AGENDA
PLANNING COMMISSION REGULAR MEETING
Wednesday, January 17, 2024, at 6:00 PM

- 1. Appointment of Chair and Vice-Chair**
 - Legislative
 - Staff Presentation: Nicholas Wharton, Town Manager
- 2. Resolution PC-2024 01: A Resolution of the Town of Severance Planning Commission approving, with conditions, a Use by Special Review application on real property located with the Town of Severance, commonly known as 10845 County Road 74**
 - Legislative
 - Staff Presentation: Shani Porter, Town Planner
- 3. Resolution PC-2024 02: A Resolution of the Town of Severance Planning Commission approving, with conditions, a Site Plan application on real property located with the Town of Severance, commonly known as 10845 County Road 74**
 - Legislative
 - Staff Presentation: Shani Porter, Town Planner
- 4. Severance Police Station Site Plan**
 - Discussion

TOWN OF SEVERANCE POLICE FACILITY RENOVATION
SEVERANCE, CO

**SEVERANCE
POLICE
DEPARTMENT
RENOVATION**

PROJECT COVER SHEET

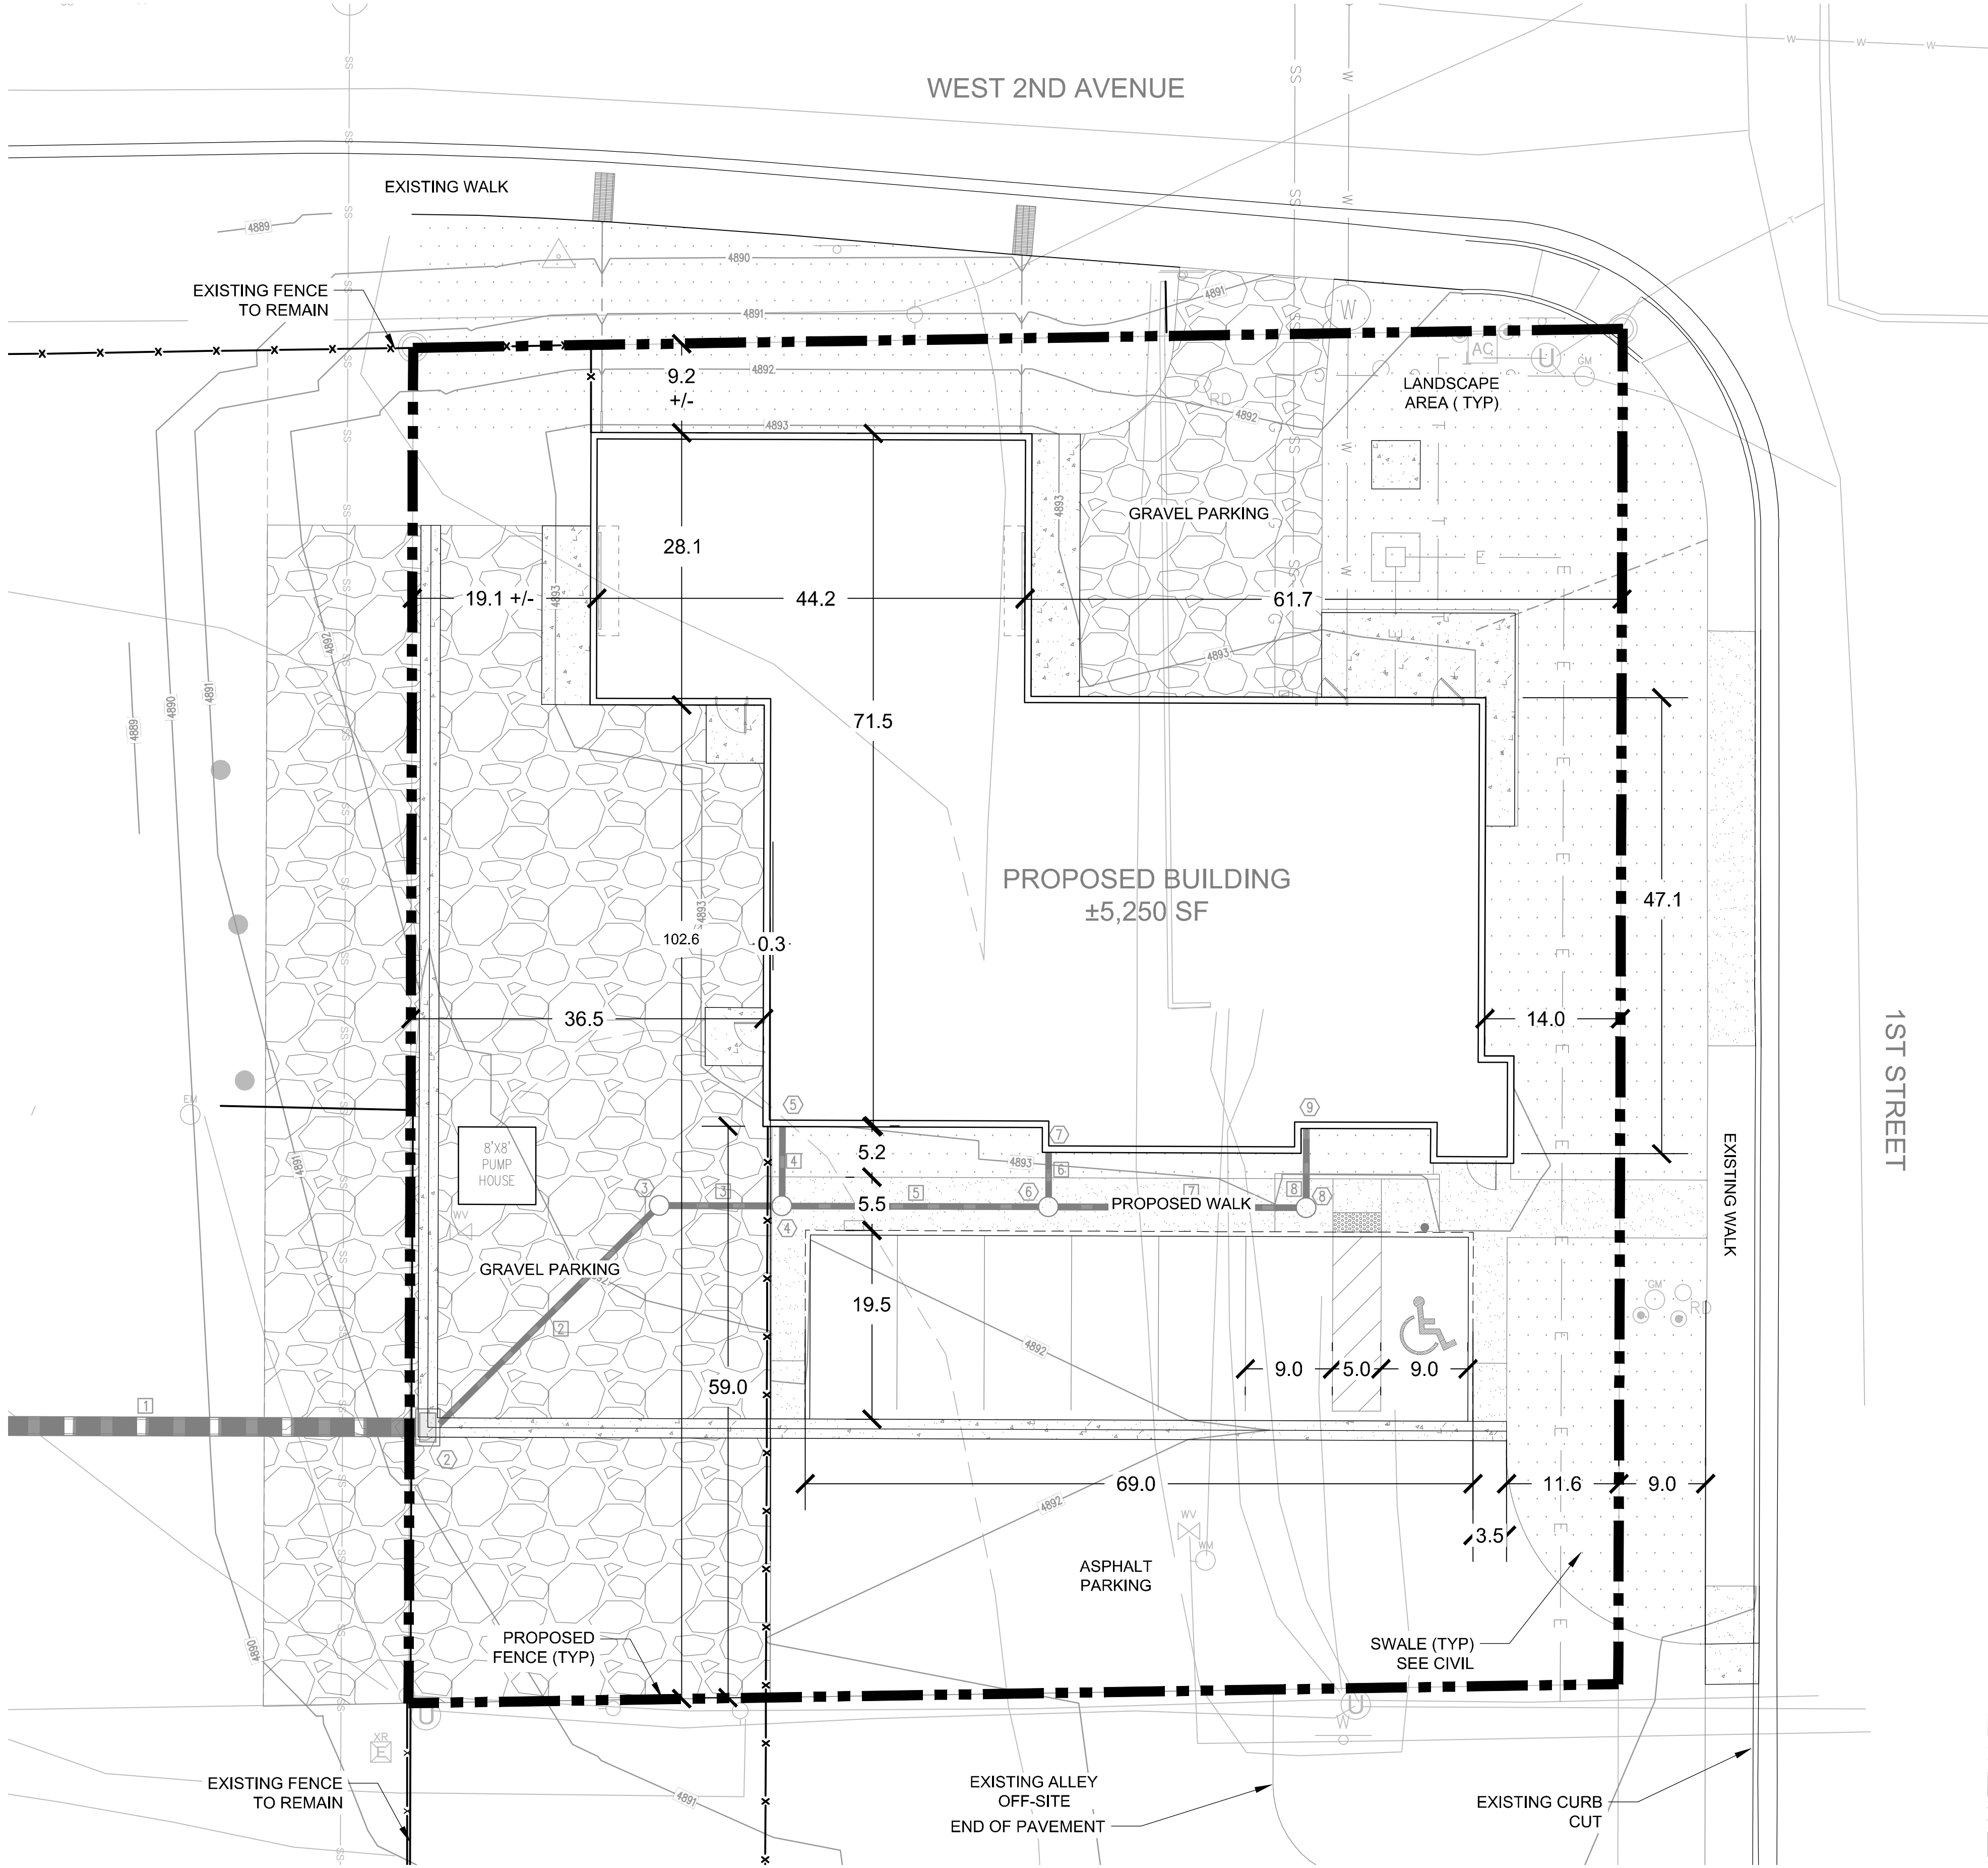
17. Sheets 1-10 Change all references from “City” to read “Town”.
18. Sheet 1 (Cover Sheet) – Add signature blocks, legal description, and title of application and development, see redlines.
19. Add an Existing Conditions/Demolition Plan and freeze/delete all demoed items from proposed plans. Add a Drainage/Erosion Control Plan (from Drainage Report). Add a Civil Detail sheet.

HORIZONTAL
CONTROL
PLAN

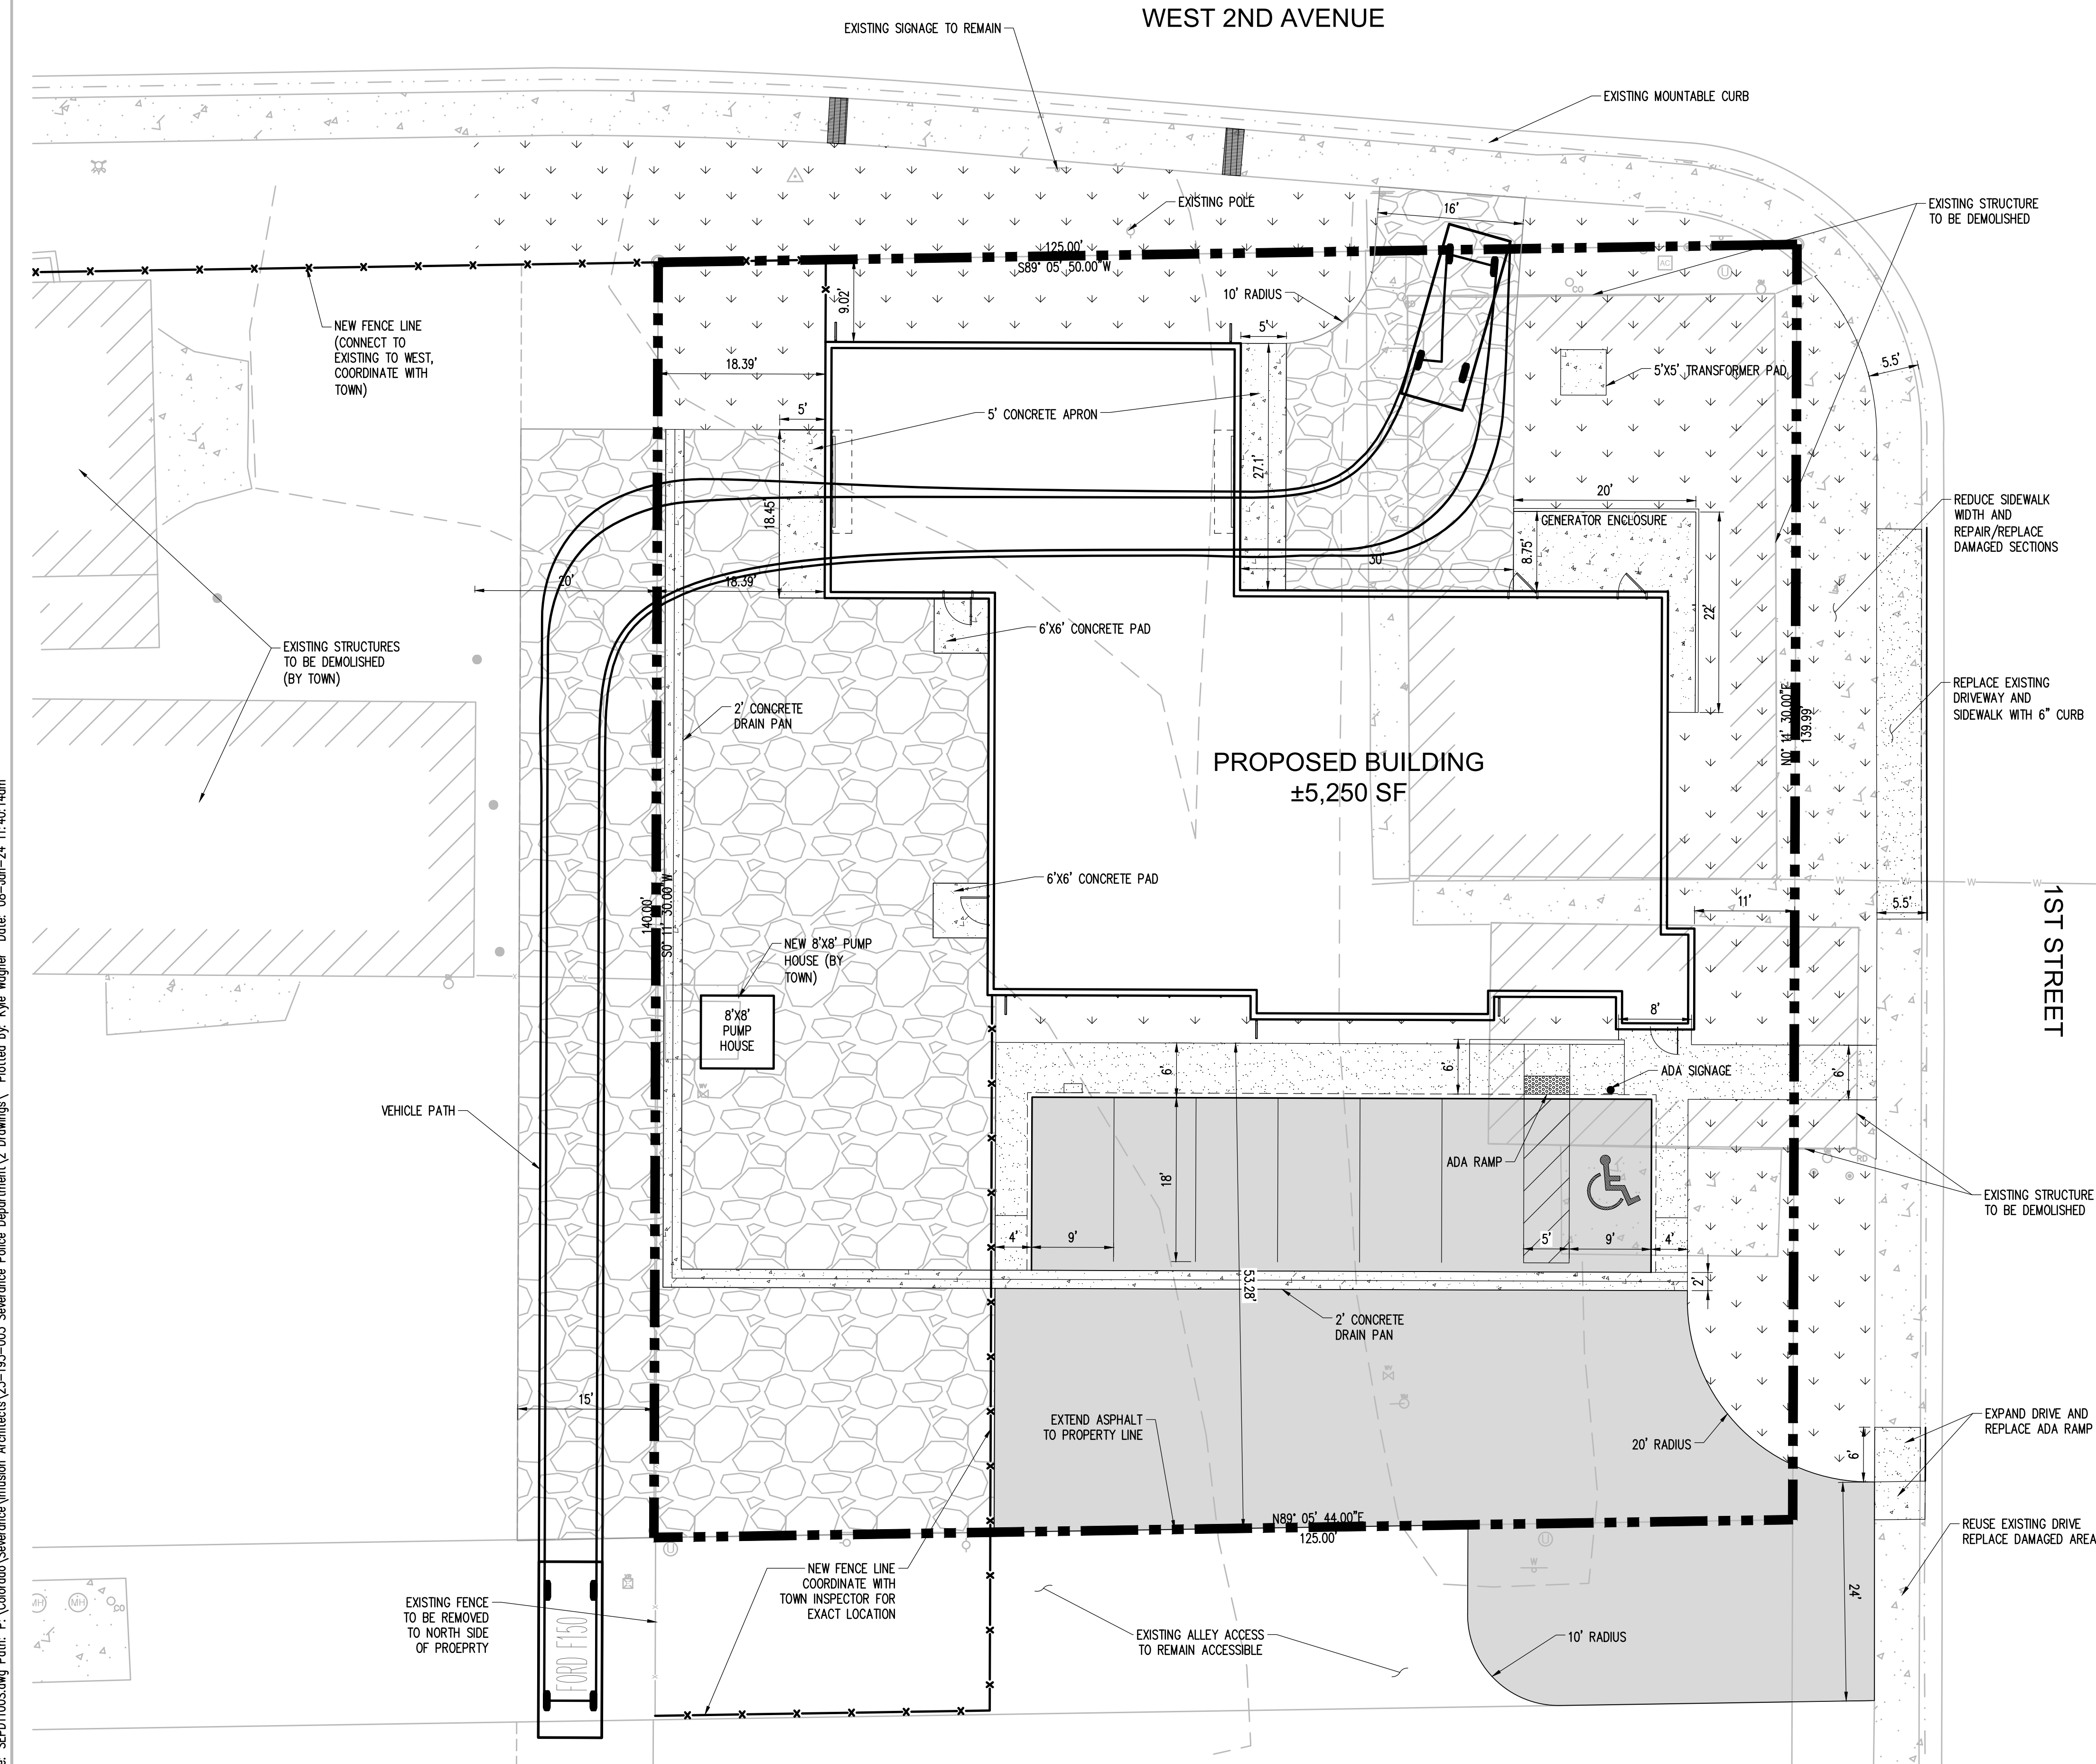
20. Sheet 2 (Site Plan) – Label the existing Alley. Will the Alley be paved? We recommend a driveway cut be installed for access off of W 2nd Avenue. Clarify existing fencing from proposed.
